**ADDENDUM NO. 3**

March 4, 2016

**Re: Sanford High School and Technical Center  
12-067-00**

**REVISED EMERG ELEC ROOM B043B**

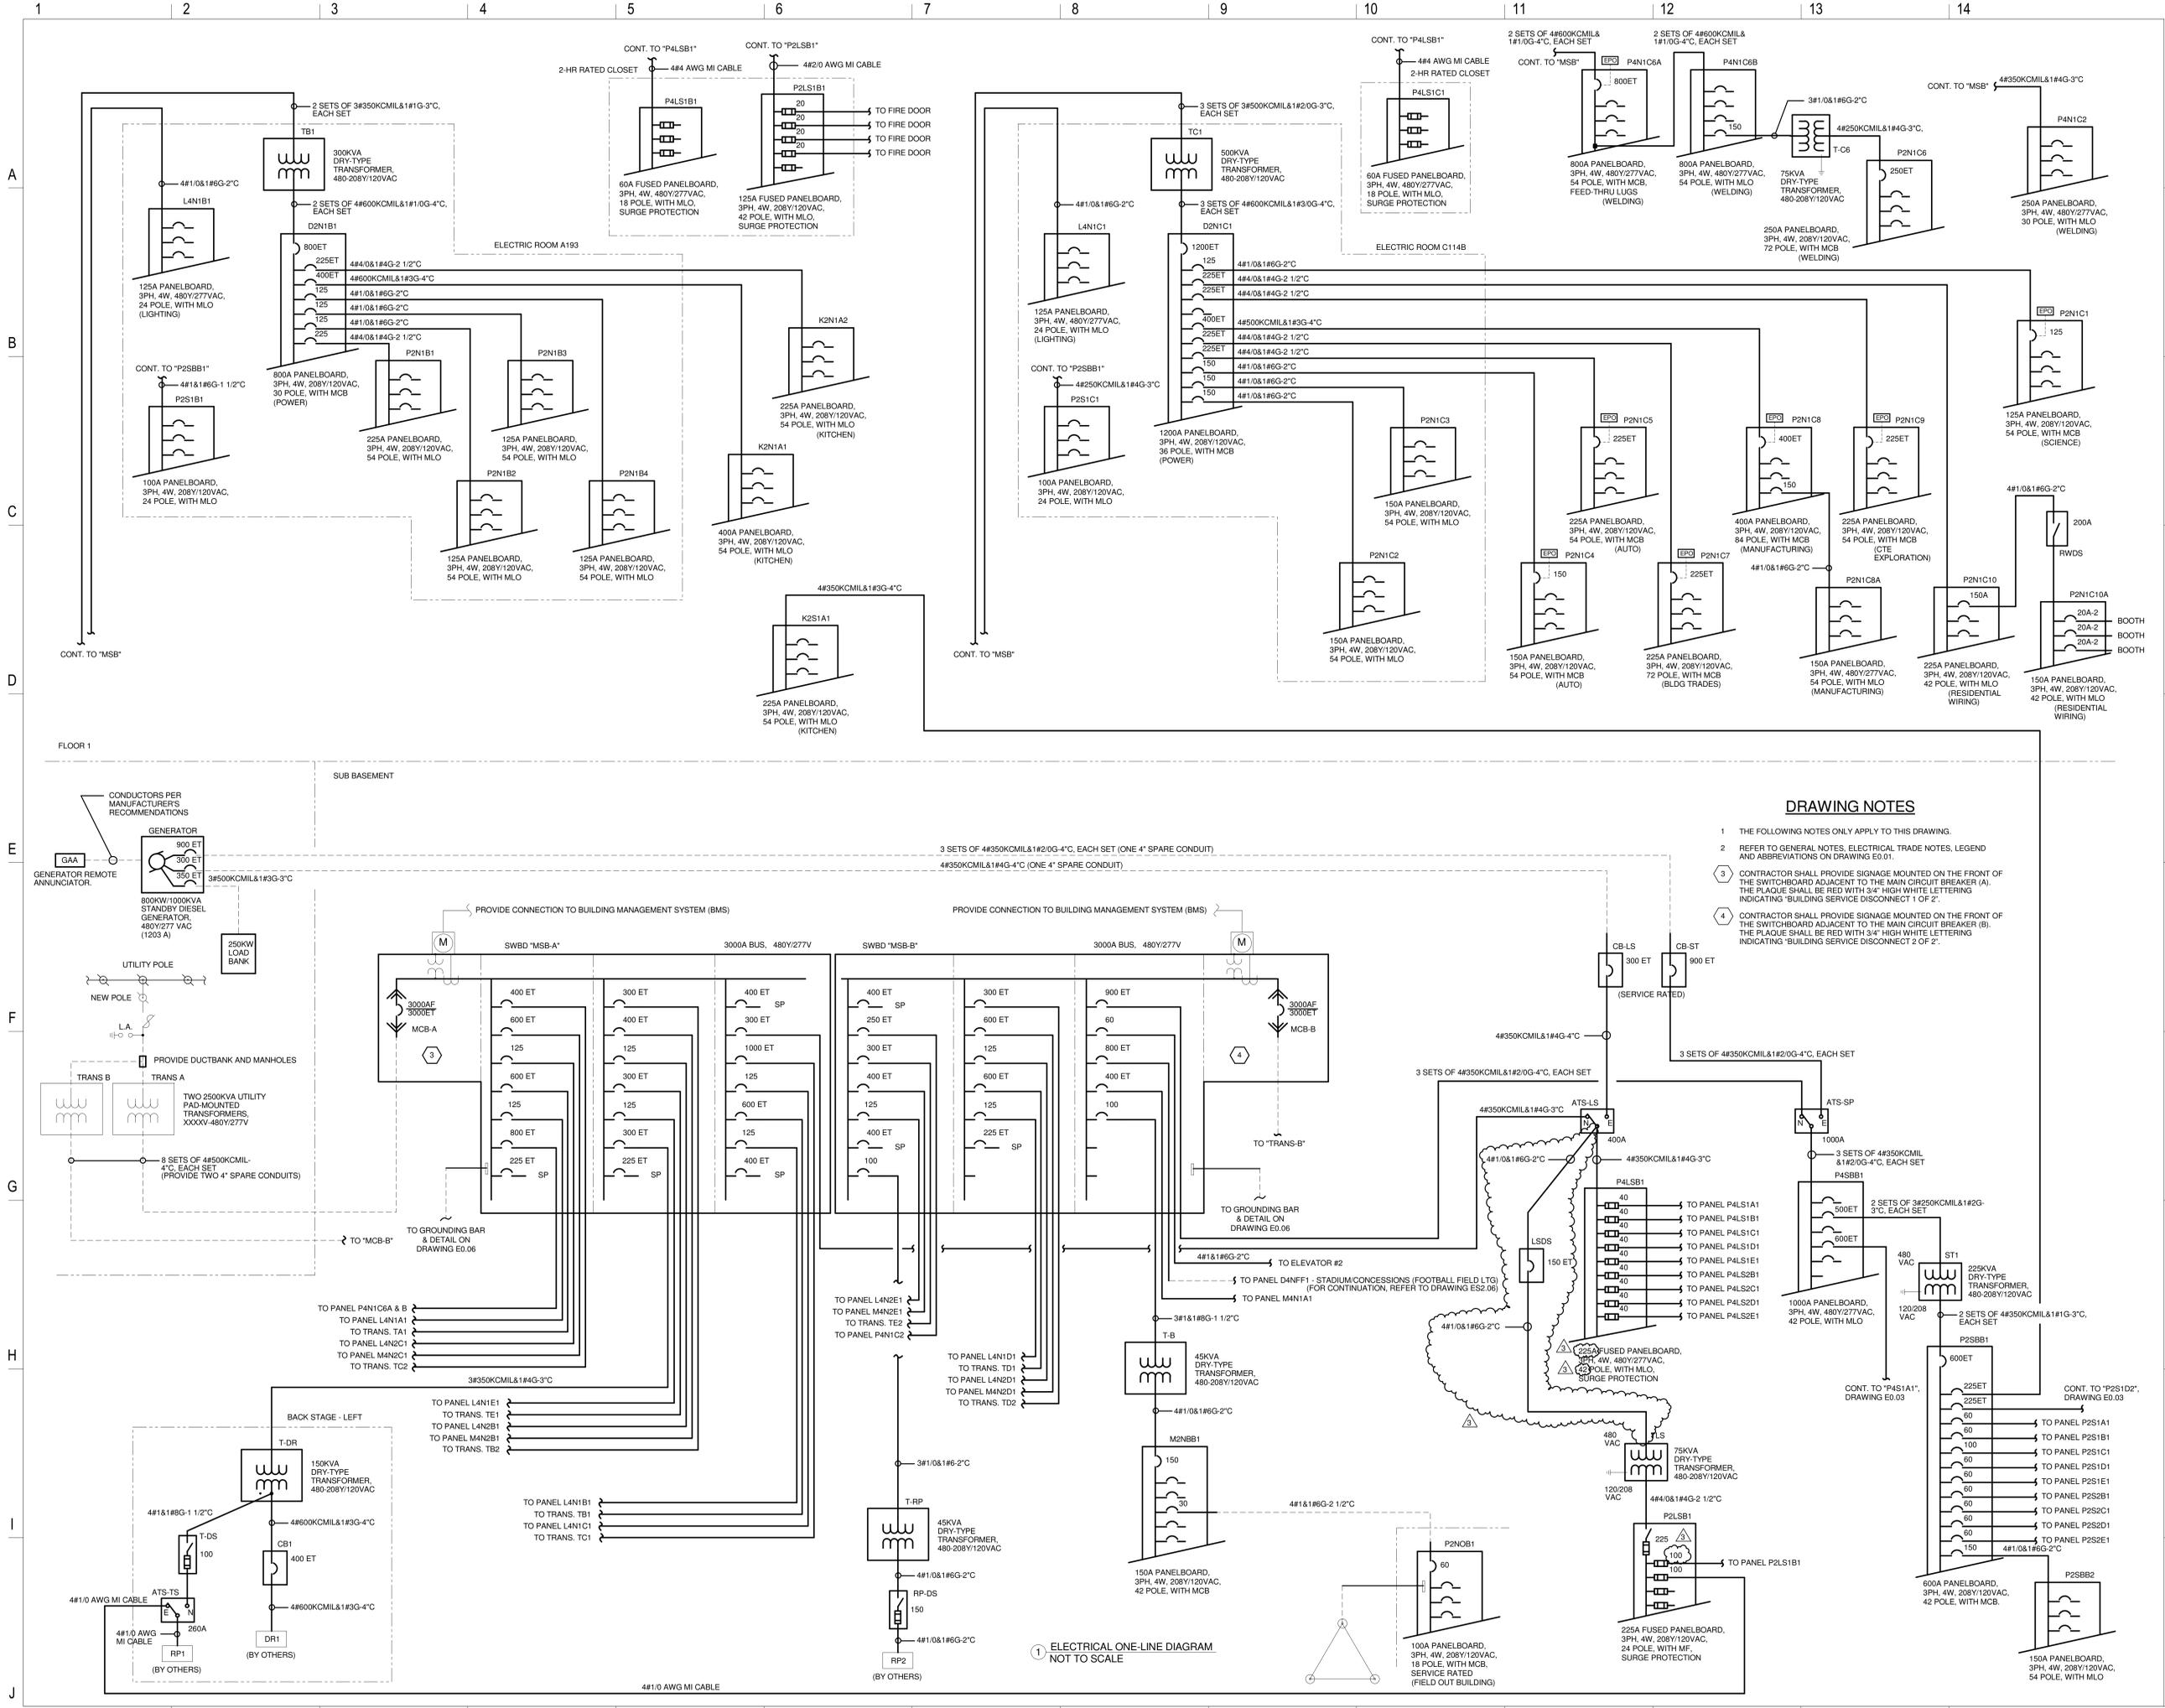
**Item No. 3.50 Reference Electrical Drawing E2.41.** Main electric room closet (2-hour rated) and equipment layout was revised. See updated Drawing. See attached sketch SKA-AD3.50 for revised Emerg Elec room B054B. Revise door B054B to a single 42x84 HM door. Revise Hardware to set 019.

CONTENT:	ELECTRICAL SITE PLAN
DRAWN BY:	C. NEWELL
PROJECT NO.:	12-067-00
DATE:	02/11/2016
REVISED:	
SCALE:	AS NOTED
<b>ES1.01</b>	
Project Phase:	
BID DOCUMENTS	
<small>COPYRIGHT © 2016 BY LAVALLEEBRENSINGER PROFESSIONAL ASSOCIATION. ALL RIGHTS RESERVED. NO REPRODUCTION WITHOUT PERMISSION.</small>

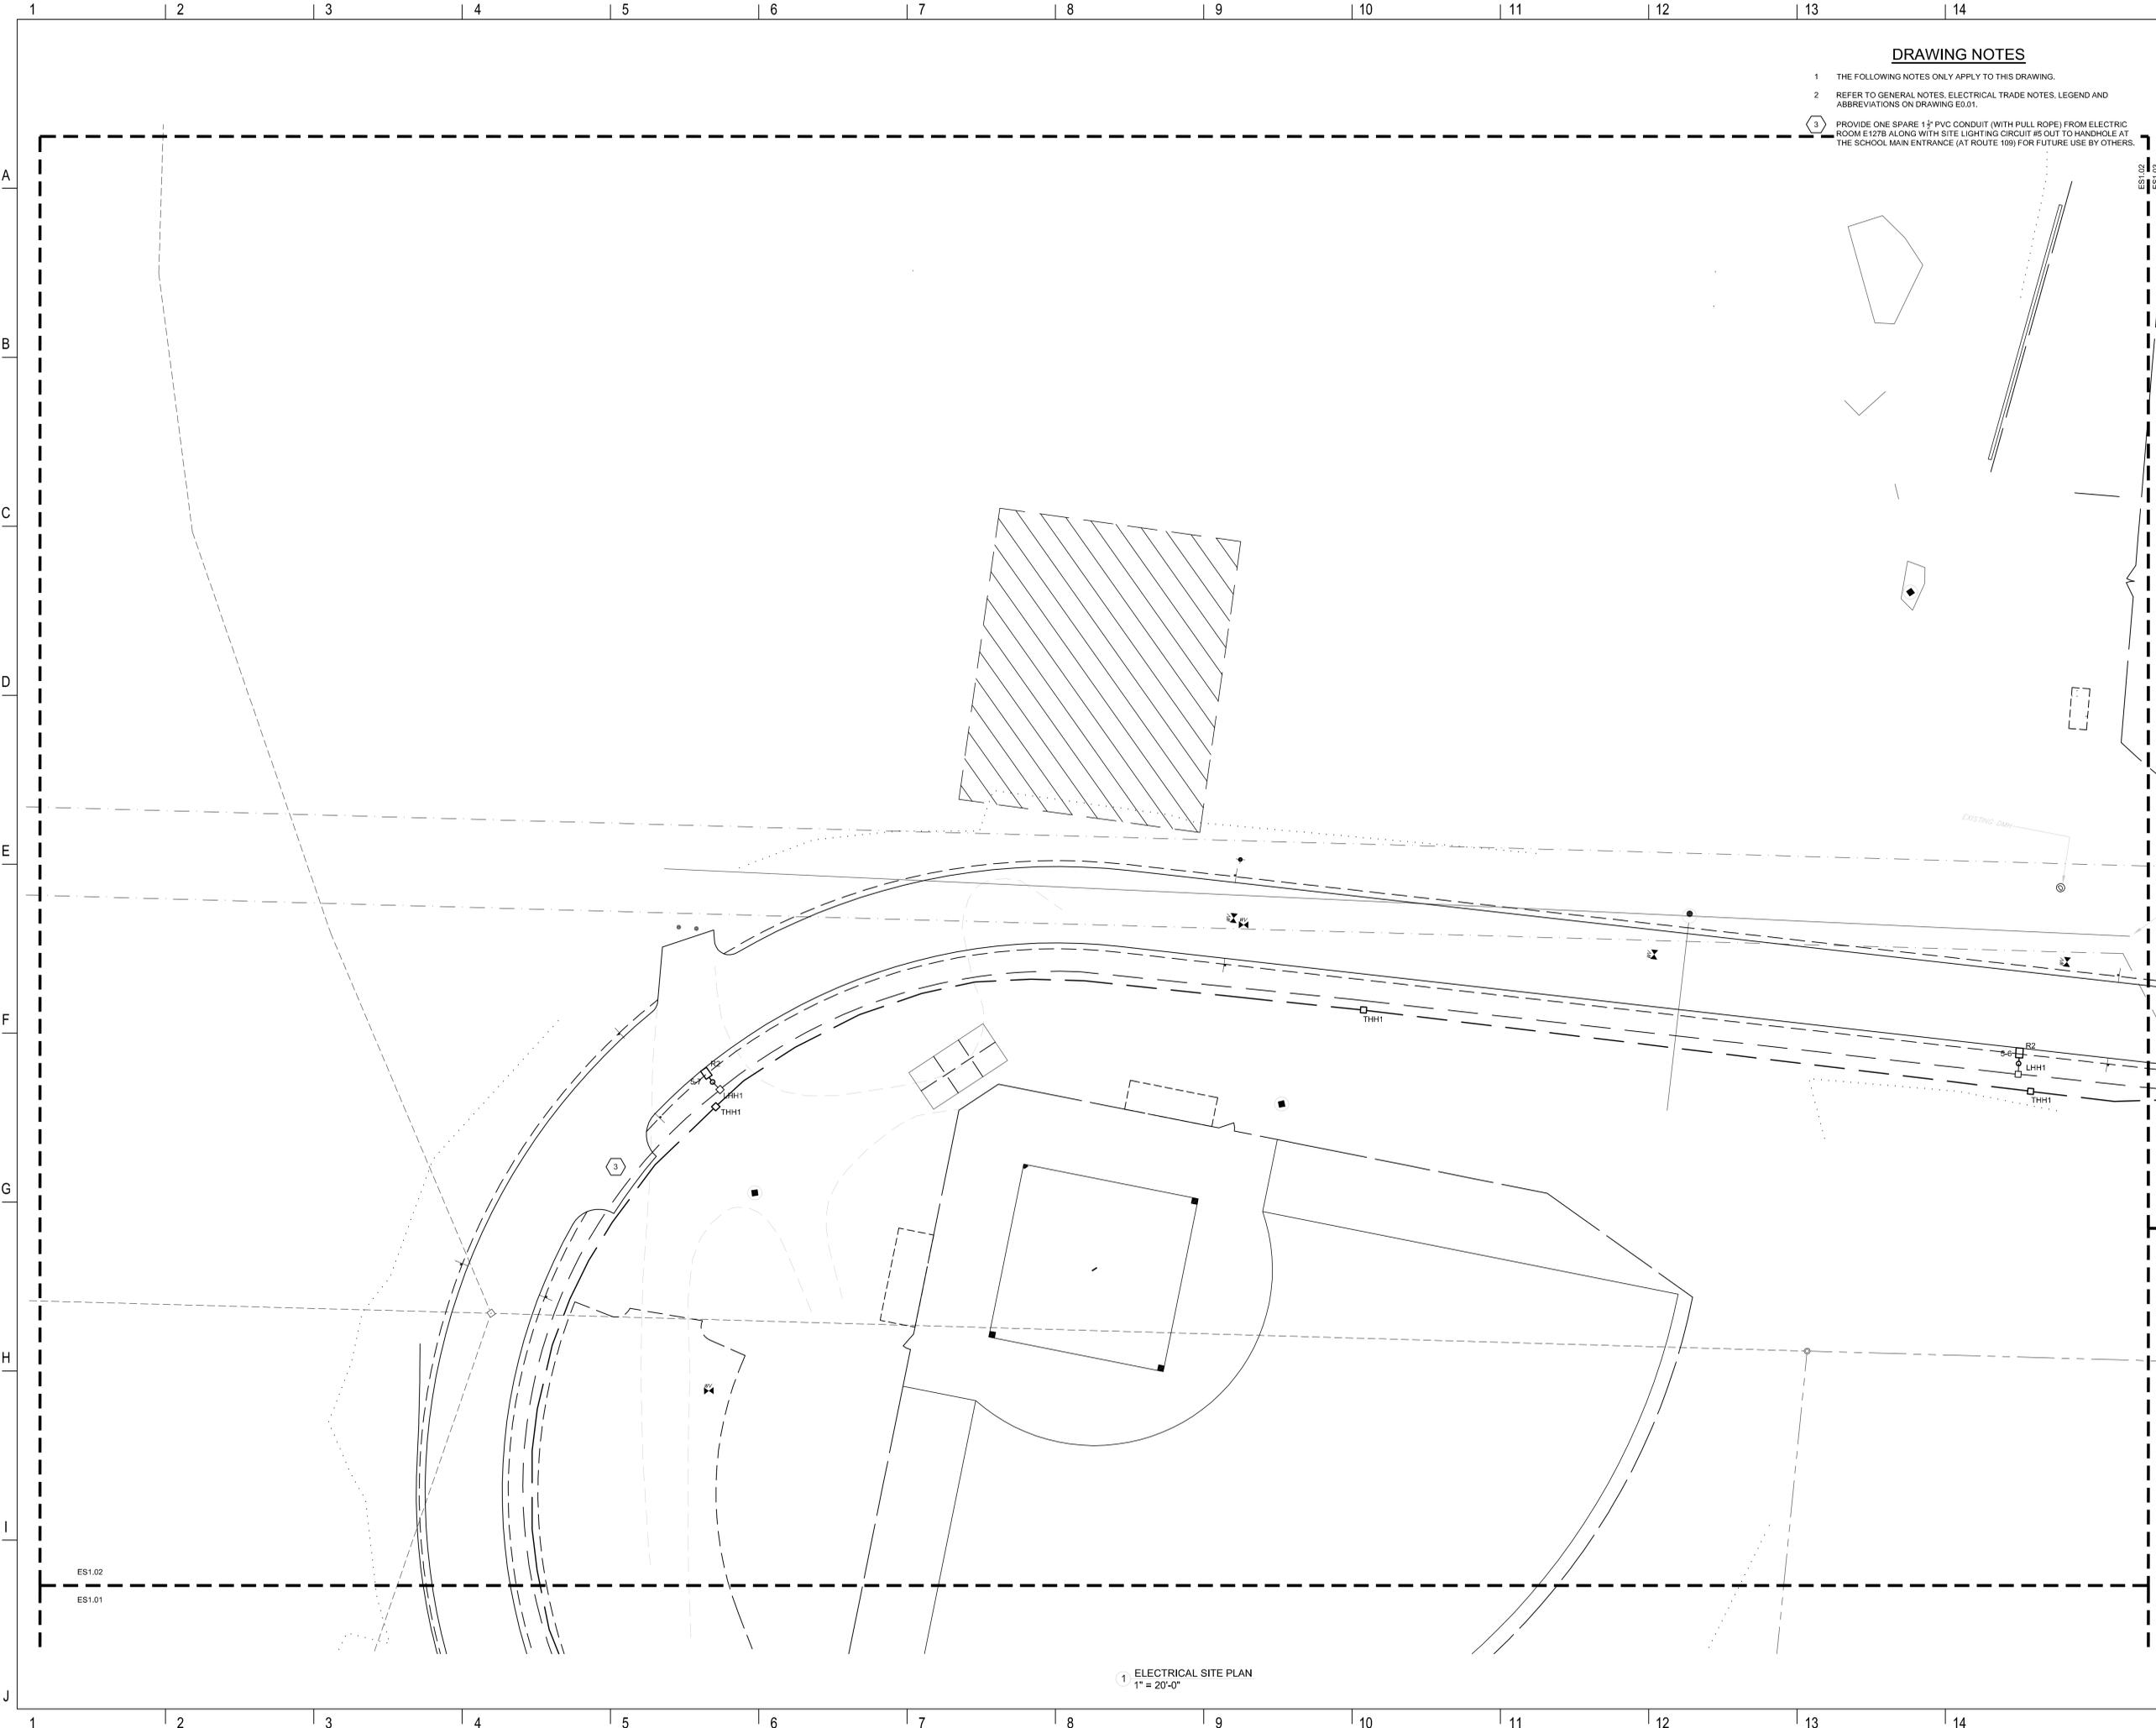
**Item No. 3.24 Reference Drawings ES1.01, 1.04, 1.08** Question: ES1.01, ES1.04, and ES1.08 have note 3 indicating Alternate 7 and that the fixture head and wiring is an "add alternate". Section 012300 indicates that Alternate 7 is fencing. However Alternate 15 is a deduct to eliminate signage lighting. Please advise the correct way to price the Base bid and these alternates?

Answer: Drawing note 3 on sheets ES1.01, ES1.04, and ES1.08 shall reference Alternate 15 as described in specification section 012300. Drawing note 3 shall be revised to say "TYPE G1 SIGNAGE FIXTURES AND WIRING ARE TO BE REMOVED UNDER ALTERNATE #15. UNDER BASE BID, PROVIDE DIRECT BURY POLE AND BASE (SEE F1/G1 FIXTURE DIRECT BURIAL POLE MOUNTING DETAIL ON DRAWING ES2.04), FIXTURES, CONDUIT, AND CIRCUITING AS INDICATED. UNDER
